PROJECT: READSBORO	PROJECT NO. : BRO 1441 (25)
DESIGN FILE NAME: 94\070\Structures\sj070xs.dgn	PLOT DATE: 05-JAN-2010
IPARM FILE NAME: sj070cx2.i	DRAWN BY: H. I. SALLS
DESIGNED BY: H. I. SALLS	CHECKED BY: E. L. RUSTAY
SQUAD LEADER: C. P. WILLIAMS	SHEET: 53 OF 60
CHANNEL CROSS SECTIONS I

STA 3+010 TO STA 3+015

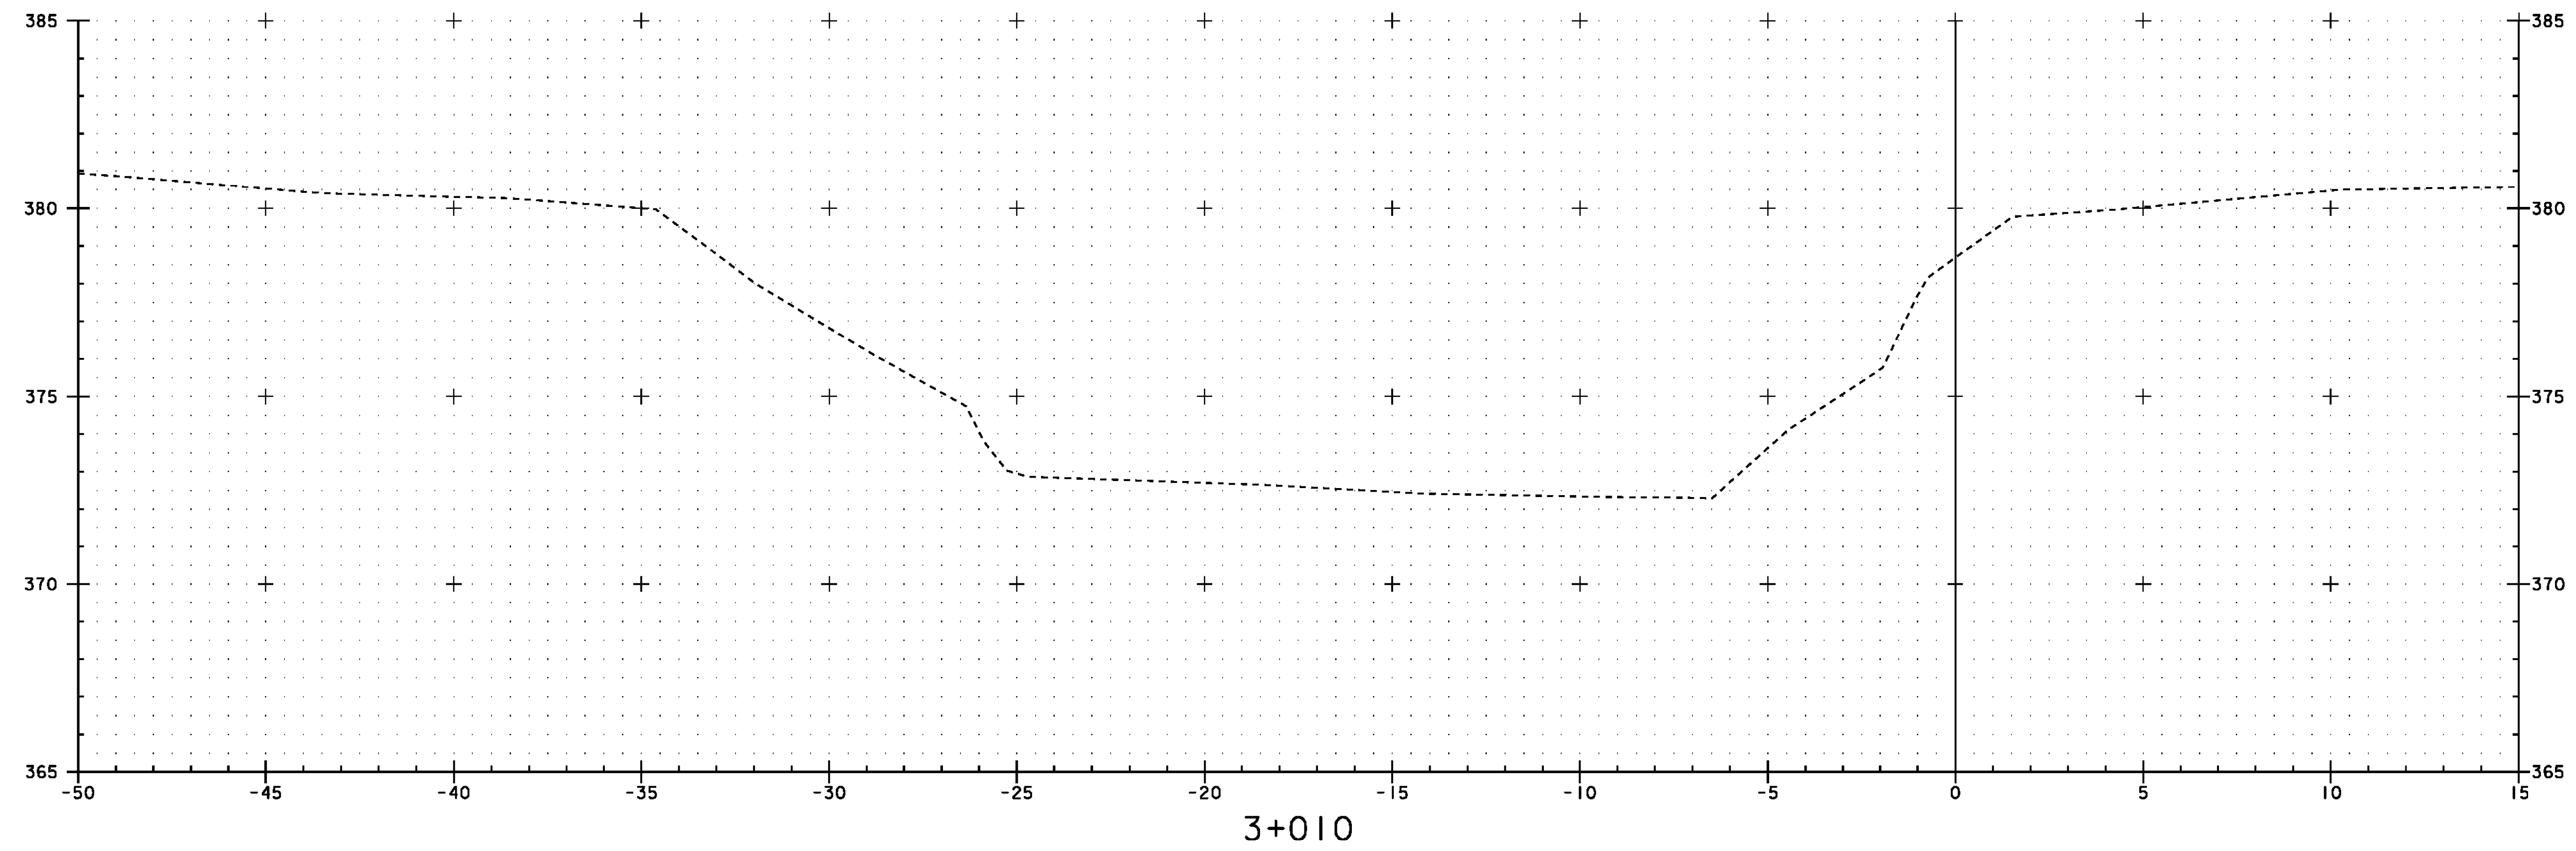
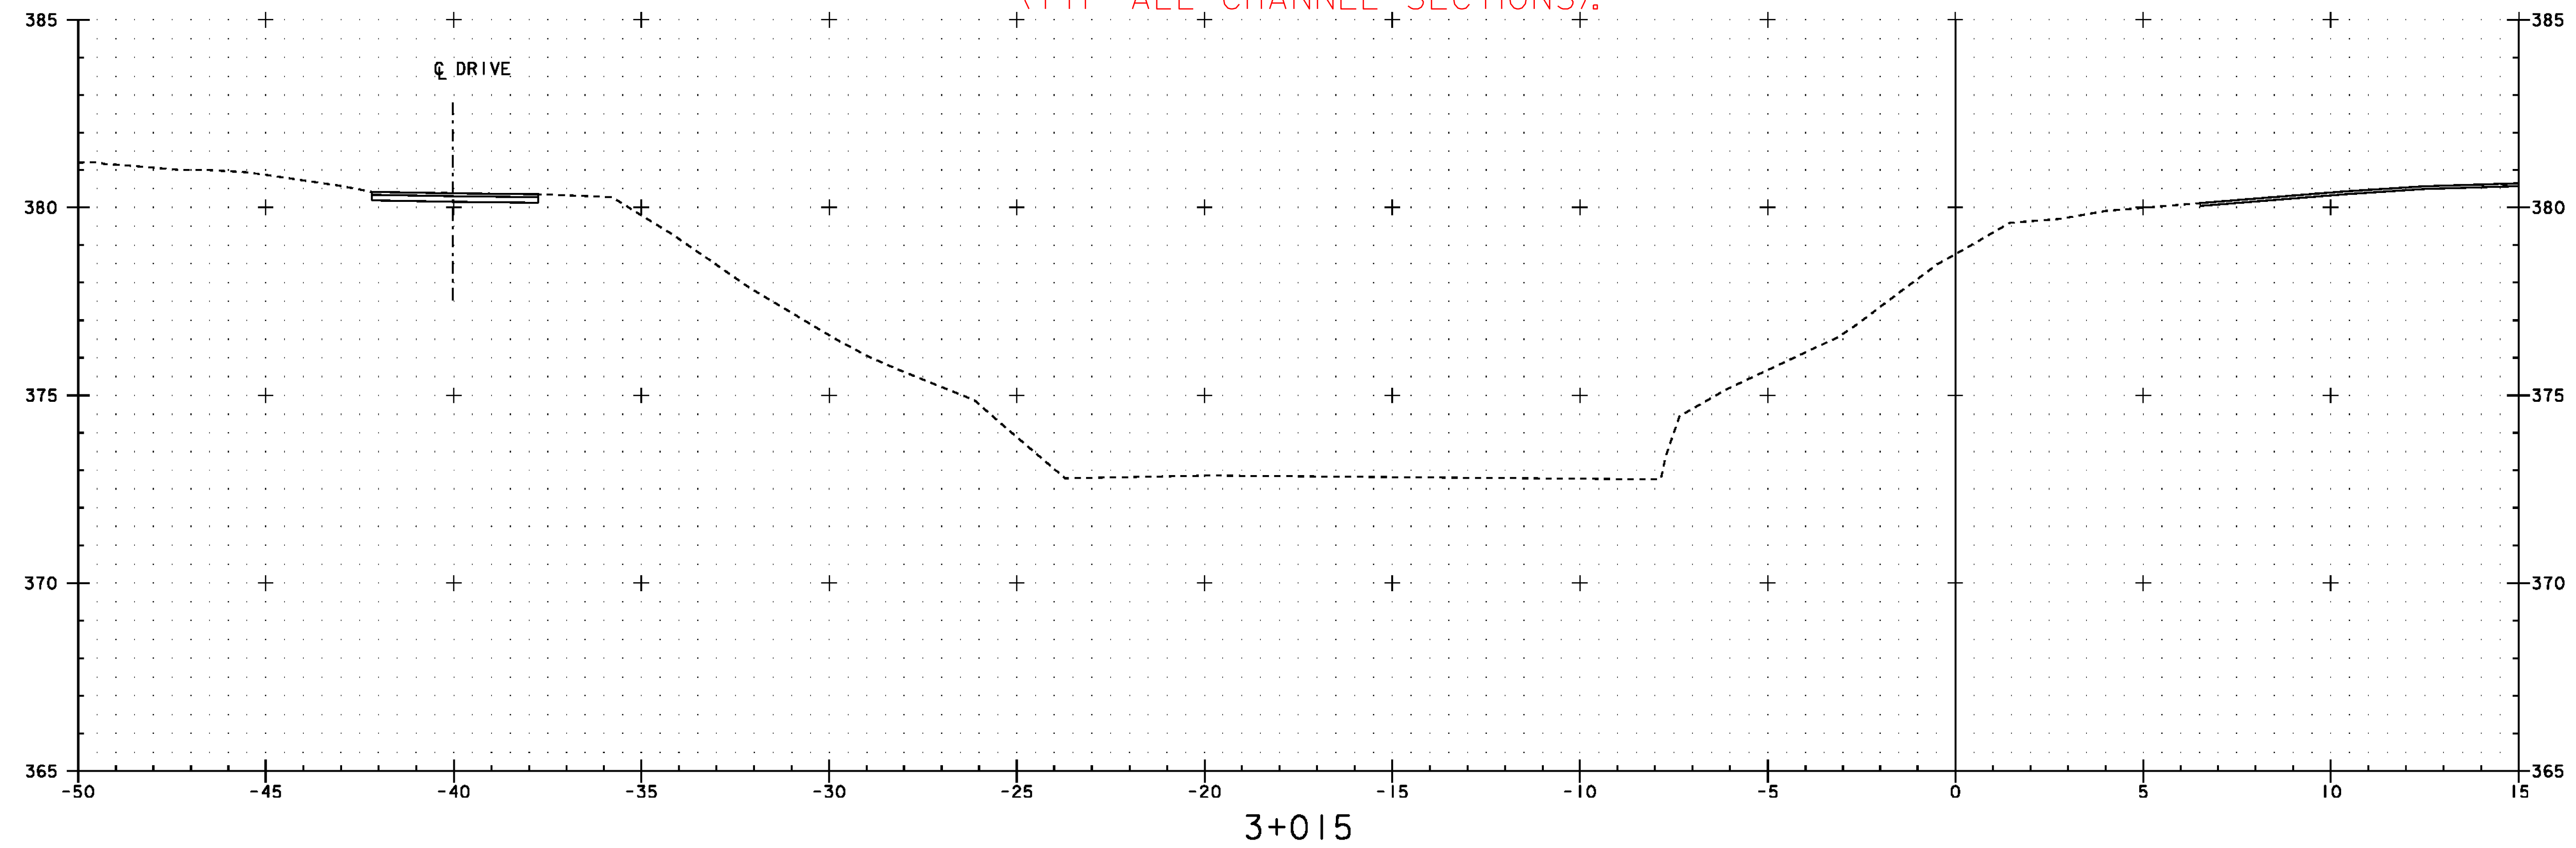
CHANNEL SECTIONS ARE NOW DIFFERENT, CHANNEL WAS MODIFIED BY A FEMA PROJECT
 WINTER OF 2011 AFTER T.S.I. WASHED STONE FILL FROM AROUND THE ABUTMENTS
 (TYP ALL CHANNEL SECTIONS).
